# County of Fairfax, Virginia

Re: Interpretation for FDP 94-Y-006-2, Tax Map 44-2 ((20)) 1B pt.: building height, minaret addition, building footprint, building connection and cellar space

TYPICAL MOSQUE ELEVATION

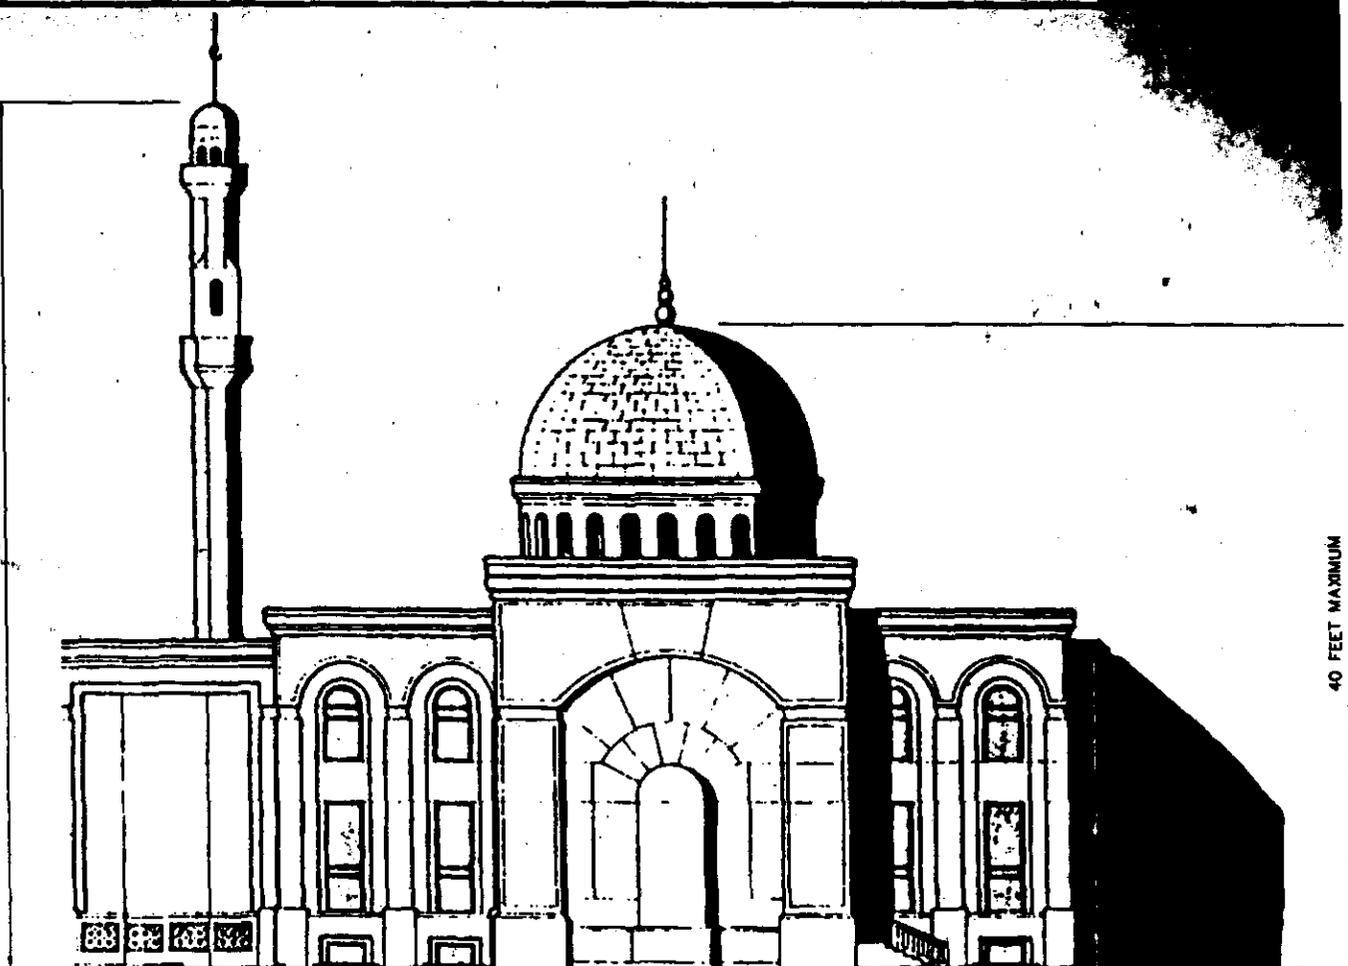
Your first question is whether a proposed increase in the height of the dome on the mosque building to 47'9" would be in substantial conformance with the approved FDP and development conditions. The approved FDP depicts an elevation for the mosque building showing a maximum building height, including the dome, of 40 feet. A copy of the FDP is attached for reference. FDP Development Condition 4 also states the following.

The maximum building height of the mosque shall be 40 feet; however, the minaret which is to be designed solely as an architectural feature as shown on the typical mosque elevation on Sheet 2 of the FDP may extend to 60 feet. The building height of the community hall and accessory residential dwelling shall be limited to 35 feet.

Your next question is whether the addition of a second minaret to the roof of the mosque would be in substantial conformance with the approved FDP and development conditions. The approved FDP illustrates one minaret in the typical mosque elevation. Development Condition 4, as quoted above, references a singular ("the") minaret. Given the FDP depiction and the Development Condition construction, it is my determination that the addition of a second minaret to the roof of the mosque building is not in substantial conformance with the approved FDP and development conditions. The submission and approval of a final development plan amendment application would be required to allow the addition of a second minaret.

Given that the FDP and development condition explicitly limit the building height of the mosque, including the dome, to 40 feet, it is my determination that the proposed increase in dome height is not in substantial conformance with the FDP and development conditions. In order to allow the proposed change in height, the submission of a final development plan amendment application, and its approval by the Planning Commission, will be required.
